RE: Kilshane Cross Recycling Park, Newtown, Kilshane Cross, Dublin 15

KILSHANE CROSS RECYCLING PARK

WASTE LICENCE APPLICATION

ARTICLE 14 RESPONSE

Quantity No: FIGURE 3.4.1

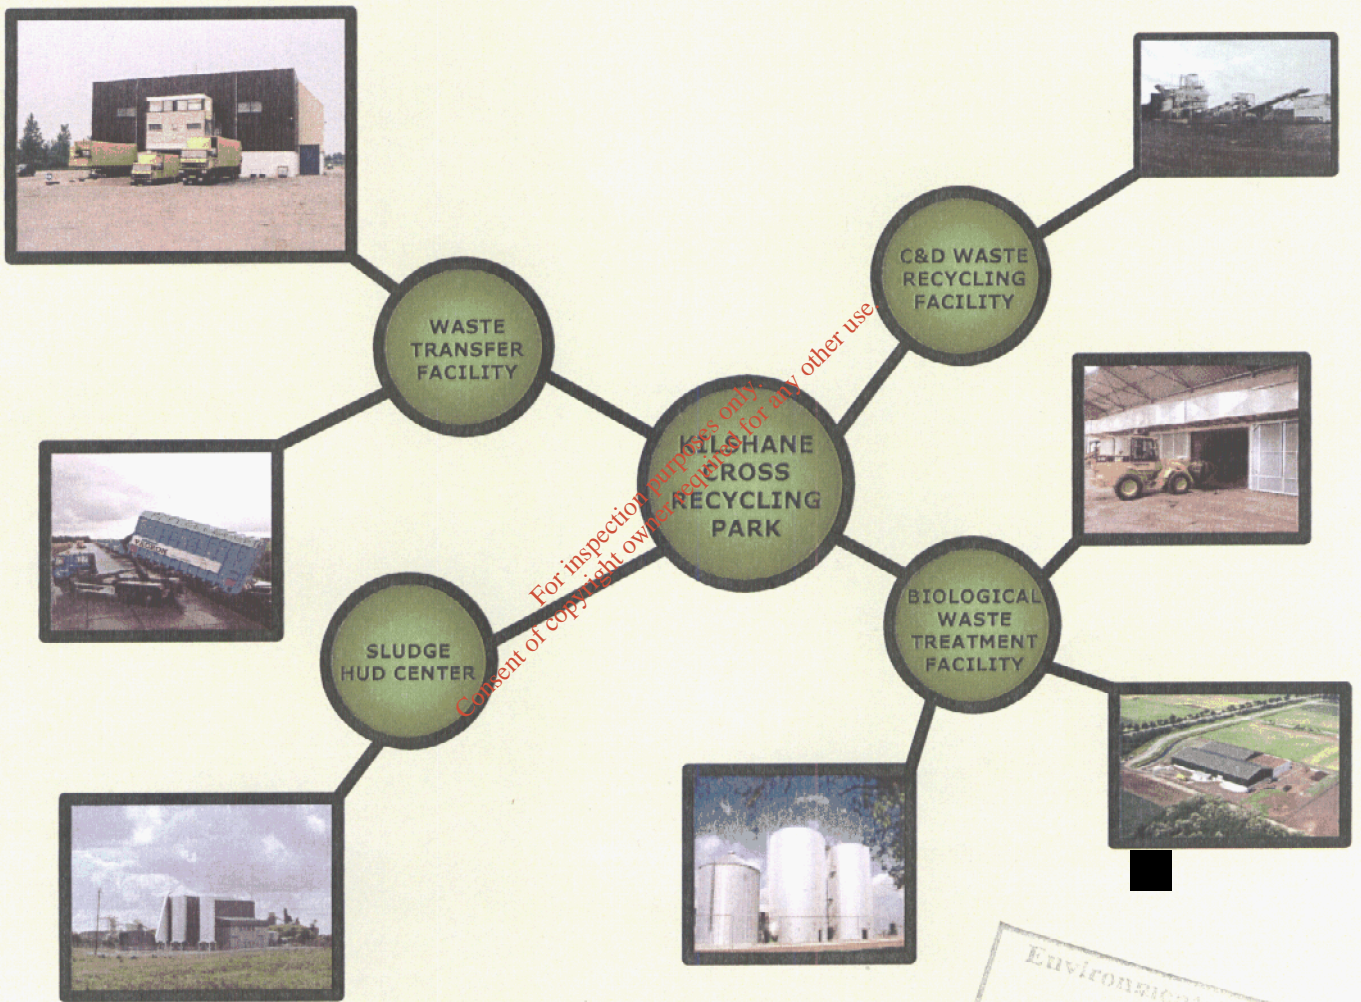
- b. *Provide an additional set of dust monitoring results for the four monitoring locations referred to in Figure 3.4.1. of the EIS as well as for one additional location at the southwest corner of the site.*

Provide at least one additional set of background noise monitoring results for both daytime and night time. Monitoring should be carried out at four noise monitoring locations referred to in Figure 3.4.1 of the EIS as well as for one additional location at the south-west corner of the site

Additional dust monitoring was carried out at the Kilshane Cross site as requested. Dust monitoring took place at five locations throughout the site, at the locations identified in Figure 3.4.1 of the EIS, as well as at an additional location in the southwest corner of the site. Please find attached Figure 3.4.1a, which is a revision of the original EIS figure and which shows the location of the dust monitoring points. Dust gauges were set up at the five nominated locations in the Kilshane Cross site. The testing period was from 24/02/06 to the 24/03/06, a total of 28 days. After this period the samples were collected and submitted to the Enterprise Ireland Air Quality Laboratory in Glasnevin, Dublin for analysis. The results are presented in the Table 3.1 below.

Daytime (08:00 – 22:00) and night time (22:00 – 08:00) noise monitoring was carried out at the six locations shown on Figure 3.4.1a on the 14th to 16th March 2006, as requested. The monitoring points are described in Table 4.1. All measurements were carried out in accordance with ISO 1996, Part 1 (Description and Measurement of Environmental Noise – Part 1: Basic Quantities and Procedures).
